NRC 2004-0104

Point Beach Nuclear Plant Unit 2
Docket 50-301
License No. DPR 27

Response to Request for Additional Information; Unit 2 Fall 2003 (U2R26)
Steam Generator Eddy Current Examinations (TAC No. MC2070)

RESPONSE TO REQUEST FOR ADDITIONAL INFORMATION POINT BEACH NUCLEAR PLANT UNIT 2 FALL 2003 (U2R26) STEAM GENERATOR EDDY CURRENT EXAMINATIONS

Figure 1-2 — General Arrangement
Page 1 of 4

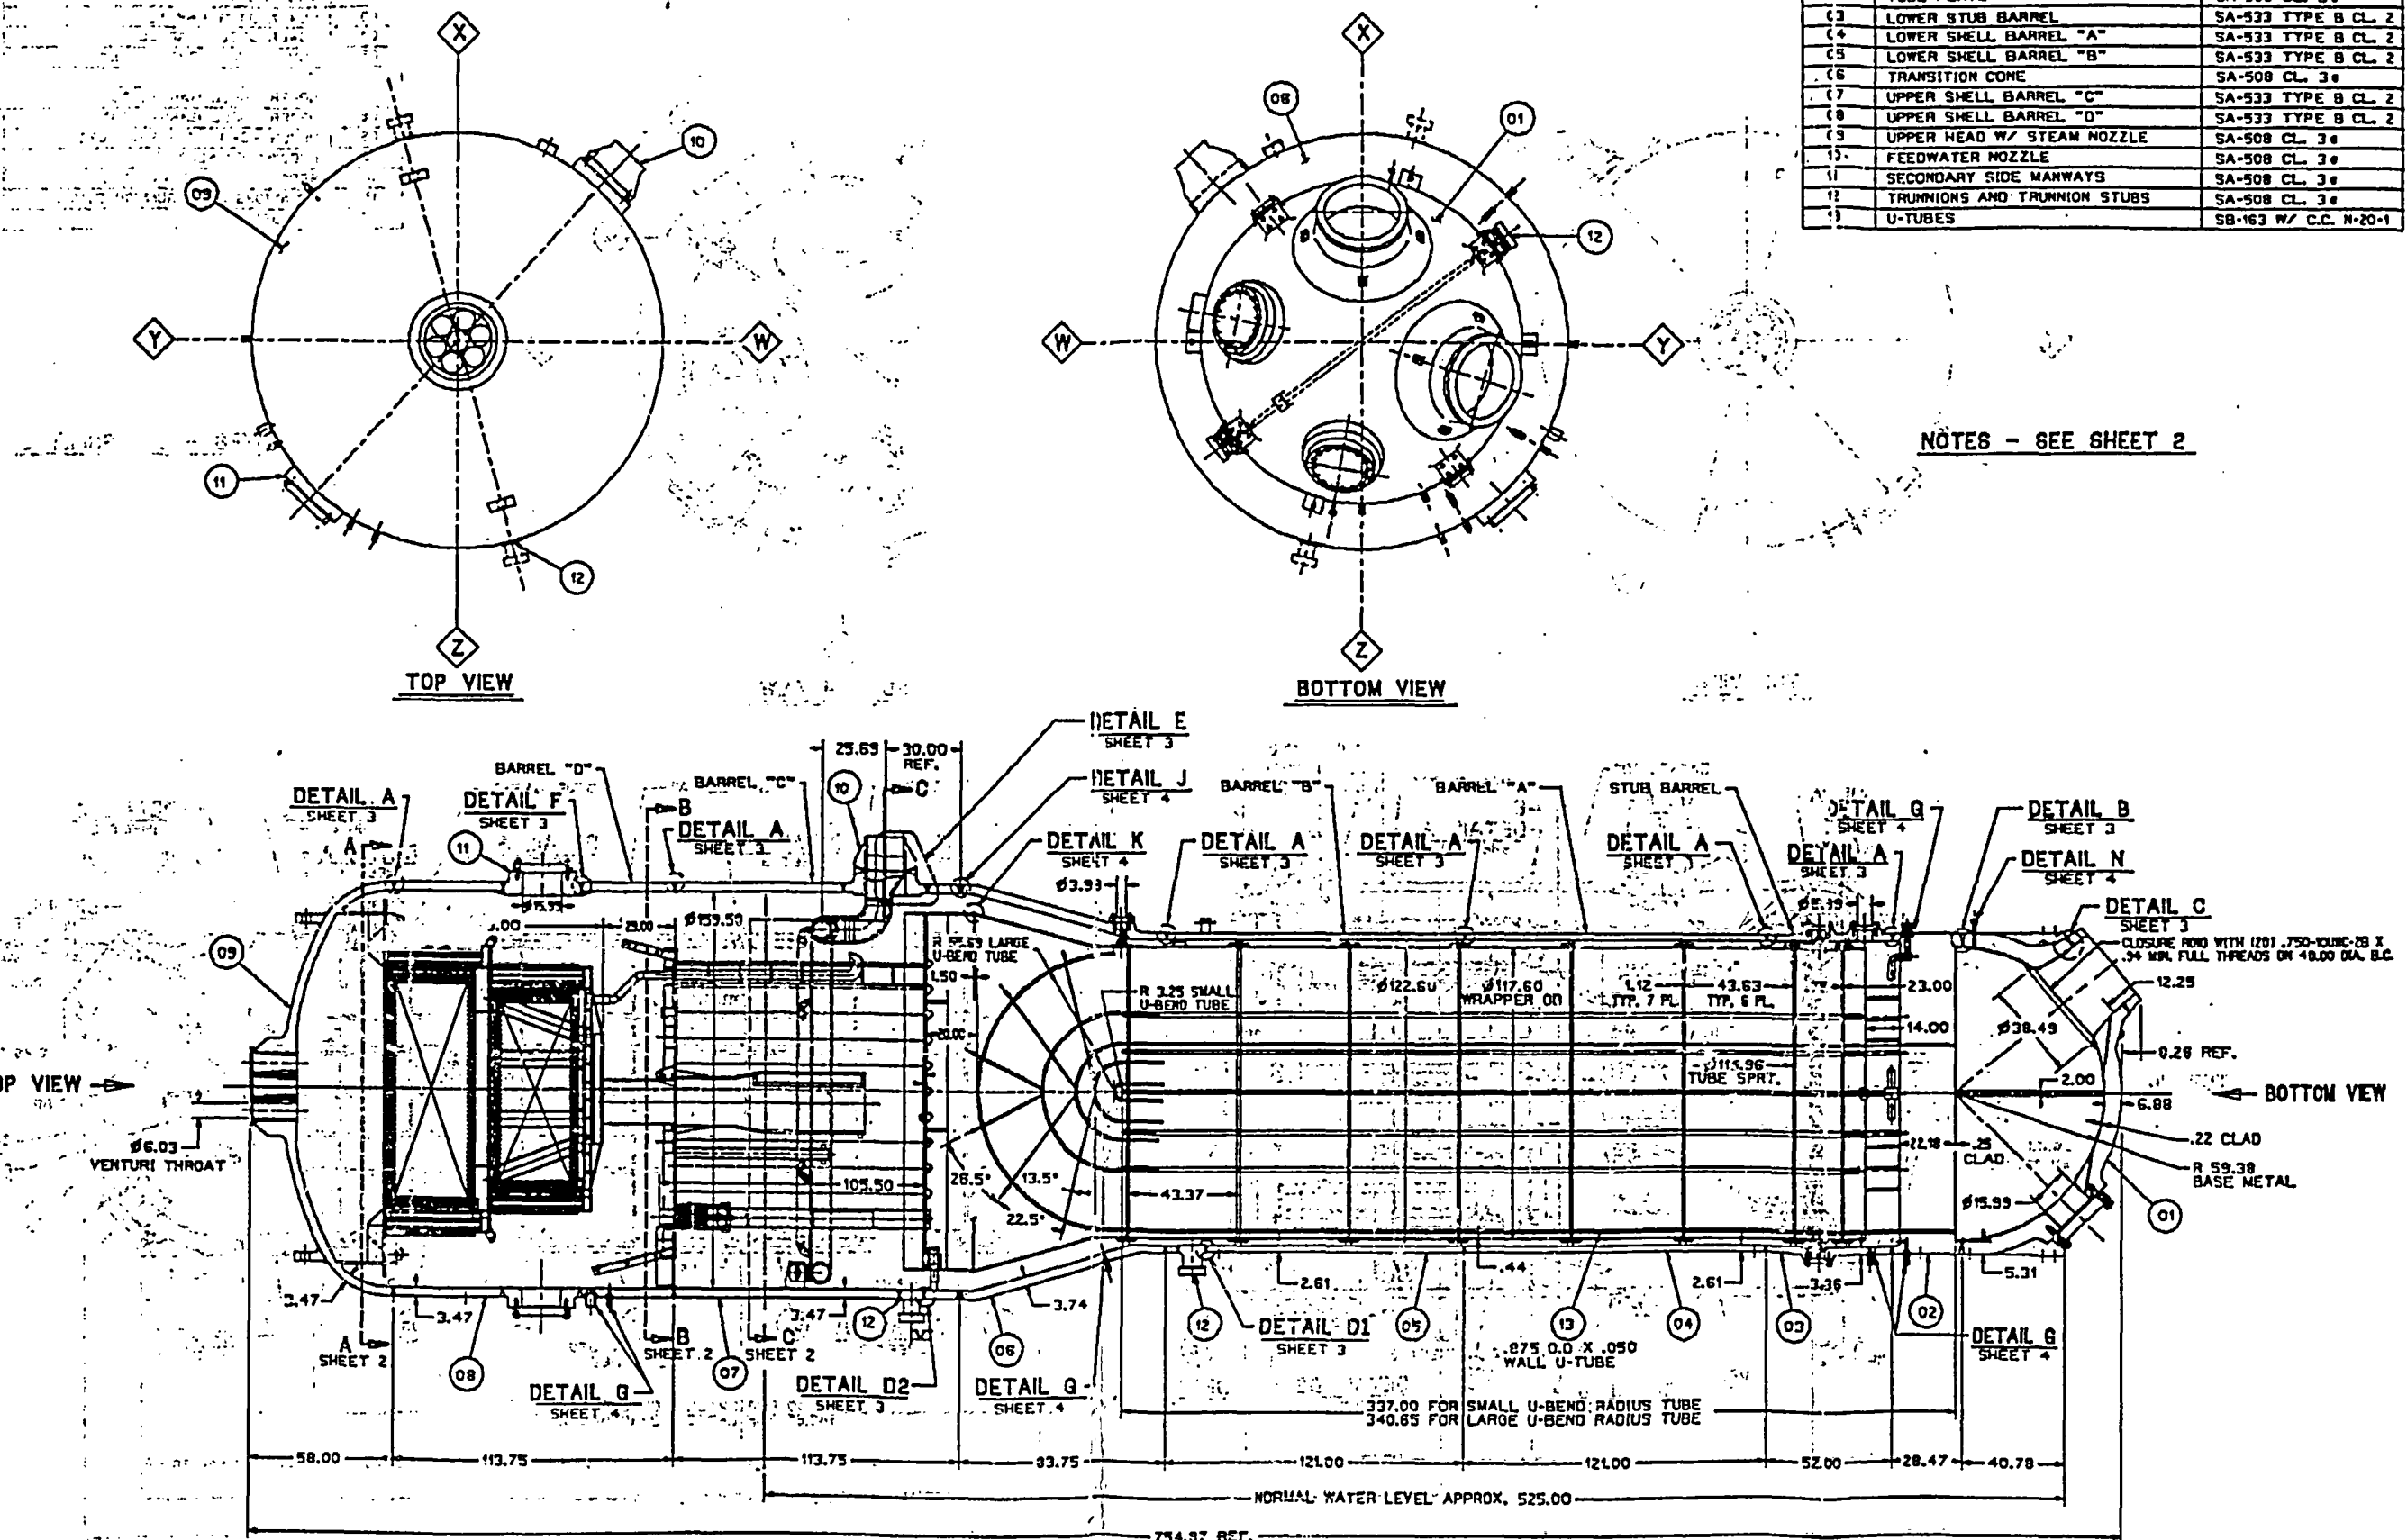
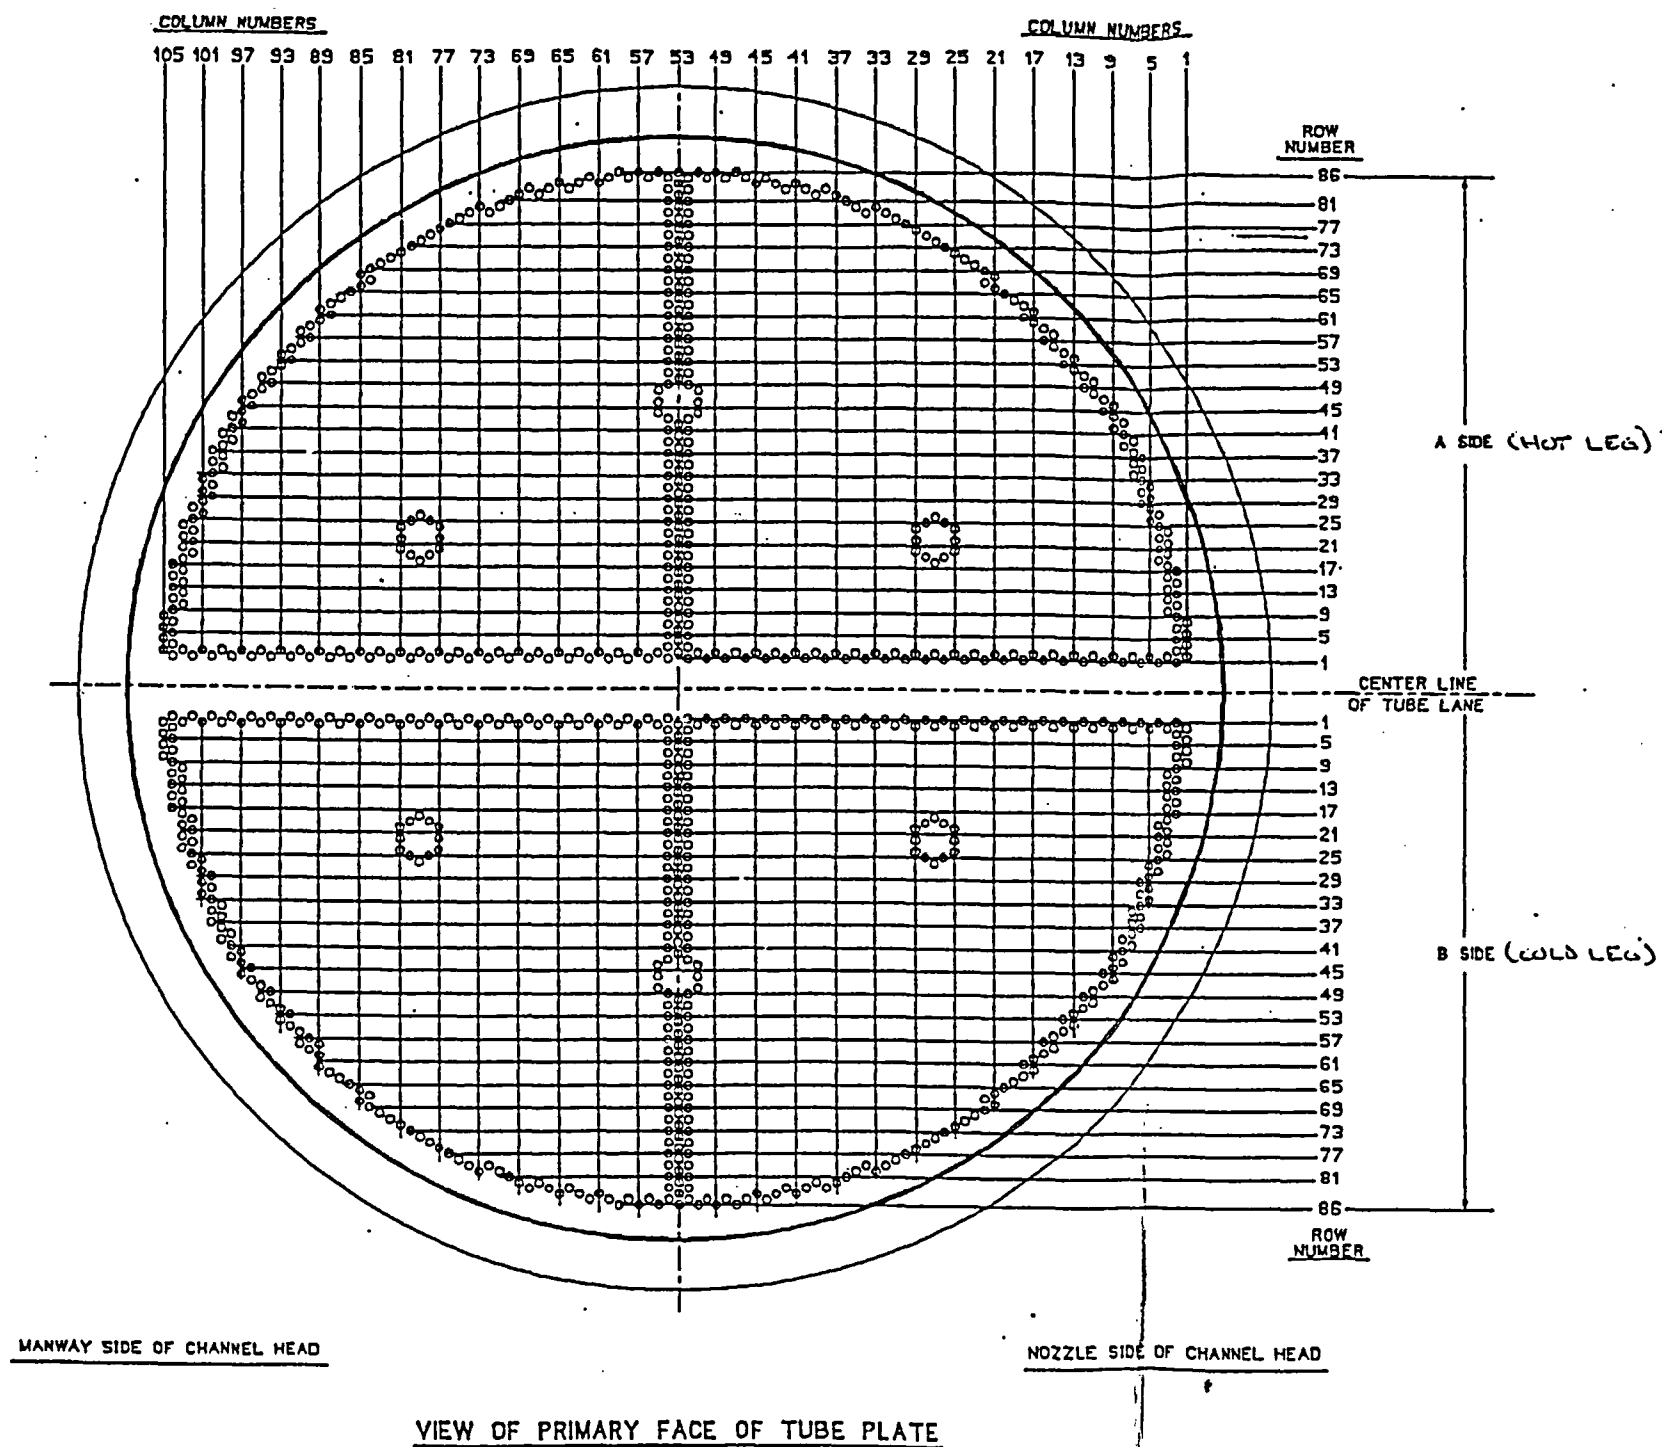
The Steam Generators (SGs) at Point Beach Unit 2 were replaced in 1996, during Refueling Outage 22, with SGs that contain thermally-treated Inconel 690 tubes. In order for the staff to better understand the location of indications, provide a tube sheet map and a schematic of the Unit 2 SGs which depicts the tube support naming conventions. In addition, provide the following design information: SG designer and fabricator, tube manufacturer, tube wall thickness, tube pitch and pattern, tube support (including anti-vibration bar) thickness, tube sheet thickness, and the radii of row 1 tubes. In addition, discuss whether any of the low row tubes (or portions of them) were stress relieved after bending.

A tube sheet map and a schematic of the Unit 2 SGs, which depicts the tube support naming conventions, are provided in Enclosure 2.

SG designer and fabricator:	Westinghouse/Westinghouse
Tube manufacturer:	Sandvik
Tube wall thickness:	0.050"
Tube pitch and pattern:	1.234" Triangular
Tube support plate thickness	1.125"
Flow Distribution plate thickness	0.74" min
Anti-vibration bar thickness:	0.190" by 0.565"
Tube sheet thickness:	22.42"
Radii of row 1 tubes:	3.25"

The tubes in rows 1 through 14 were stress relieved after bending.
